GENVAC Aerospace Corporation  
110 Alpha Park  
Cleveland, OH 44143  
January 17, 2019

SUBJECT: GENVAC AEROSPACE, REQUEST FOR ADDITIONAL INFORMATION  
FOR A NEW EXEMPT DISTRIBUTION LICENSE

REF: Letter from Ms. Xu dated 18 December 2018

# CARDBOARD BOX UNFOLDED HOLDS 100 UV LIGHT SOURCES

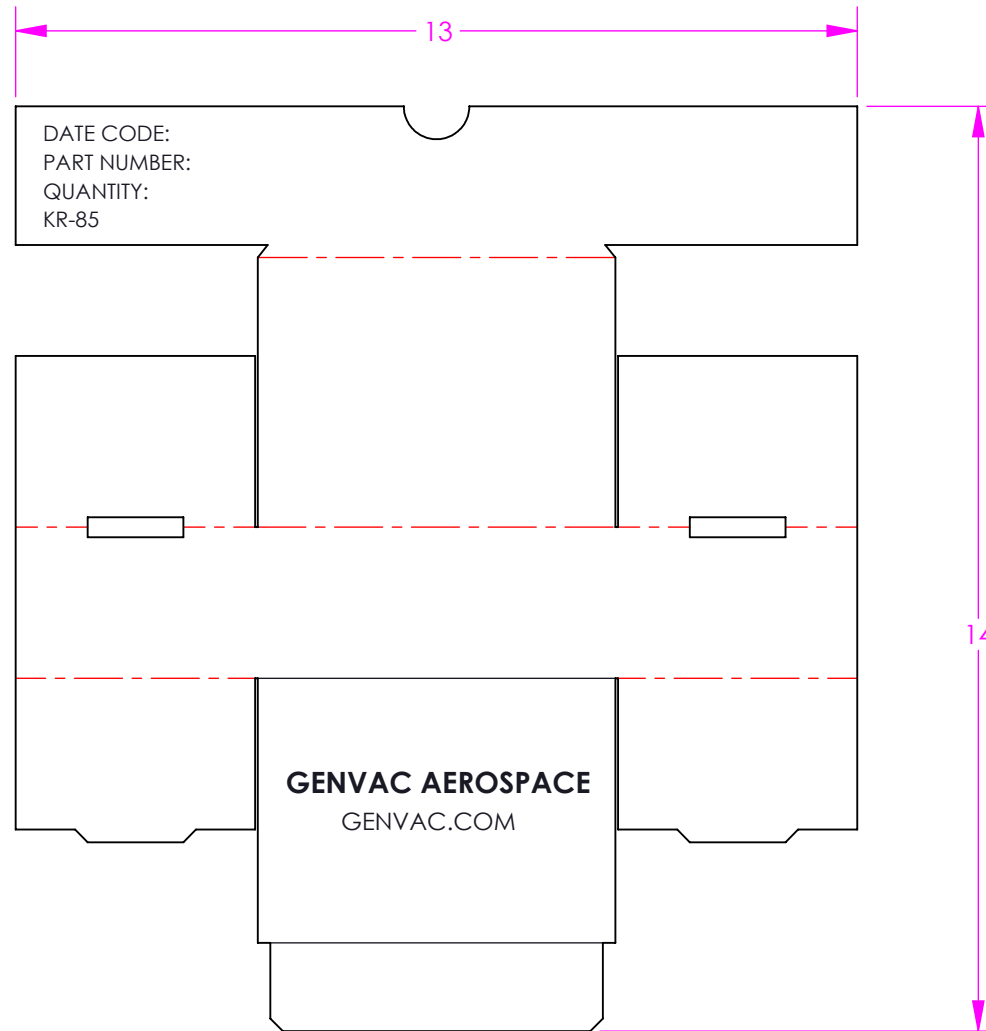
2. *“Provide the proposed method of labeling, or marking each unit, and its container with the identification of the manufacturer, or initial transferor, of the product and the byproduct material in the product.”*

A monogram is placed on each lamp, as pictured in attachment 1 and attachment 2. There is also a label on the outside of the lamp package, as shown in attachment 3. In attachment 4, we have included a larger copy of the monogram that appears on each lamp.
